# THE GLIDING FEDERATION OF AUSTRALIA

GFA/AD 217
SZD 20
19/11/1981
Issue 1
Sheet 1 of 2

AIRWORTHINESS DIRECTIVE GLIDERS/POWERED SAILPLANES

Incorporation of inspection hole in the vertical fin.

Fig .1.

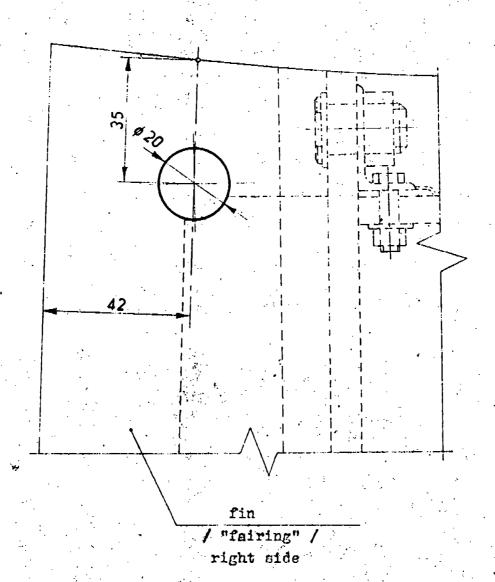
- (1) Mark hole location on the righthand side of the fin, using the dimension shown on Fig 1.
- (2) Using a hole saw cut a 20 mm dia. hole.
- (3) Seal the hole edges and repair any local damage with polyurathane lacquer.
